Vaquero Village

Revised: 4-28-17
Vaquero Village Cluster Subdivision Phase 1
 WEBER COUNTY, UTAH
Landscape & Irrigation Plan

Project Info.
 Engineer: NATE REYE
 Drafter: C. KINGSLEY
 Begin Date: 1-4-16
 Name: VAQUERO VILLAGE CLUSTER SUBDIVISION PHASE 1
 Number: 6352-01

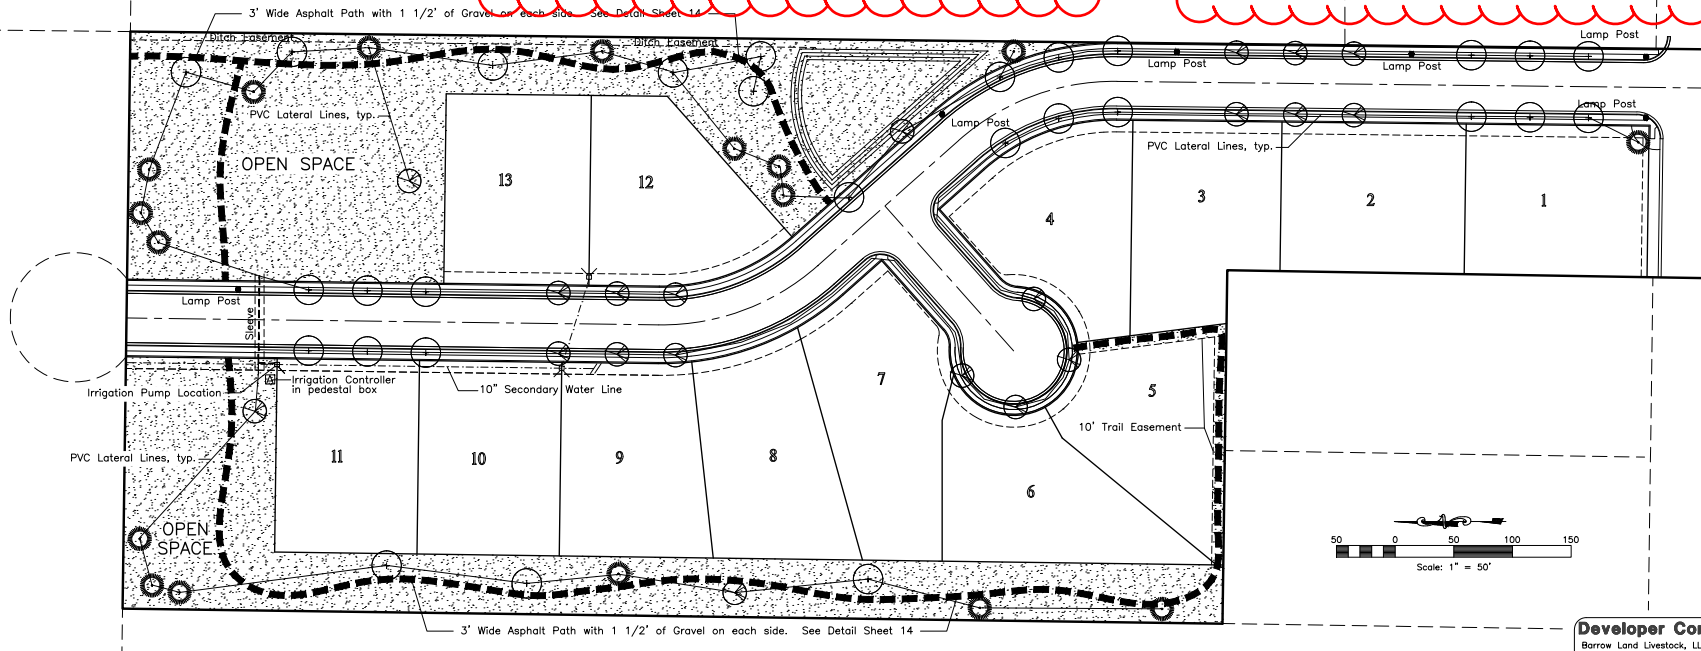
What type of native grasses are you proposing in the open spaces?

50% of the landscaping must be in turf grass. It is recommended that the open space is not seeded with native grasses. There should be a mixture of flower beds, trees, turf grass and drought resistant plants in order to meet the requirements of 108-1-4(3).

the landscape plan shows 28 autumn blazes. Please add two more trees.

Total area of open space=162,637 sq ft
 50% should be in turf grass (81318.5 sq ft)
